IDLE MIXTURE ADJUSTING NEEDLE / ELECTRA GLIDE, SPORTSTER

HARLEY-DAVIDSON MOTOR CO., INC.

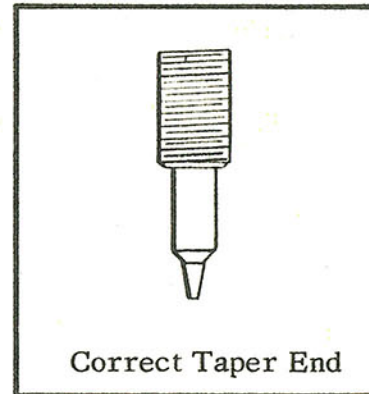
A quantity of Tillotson HD carburetors with defective idle mixture needles were received from the supplier and were used in production. These needles have an incorrectly formed blunt end instead of the correct tapered end as shown below.

If you have any 1970 Electra Glide or Sportster which has an erratic or unstable idle mixture setting, requires frequent adjustment, and requires an idle setting over 1-1/8 turns open, unscrew the needle and inspect the tip to see if it is formed correctly. Replace idle mixture needle, part No. 27688-66, if defective.
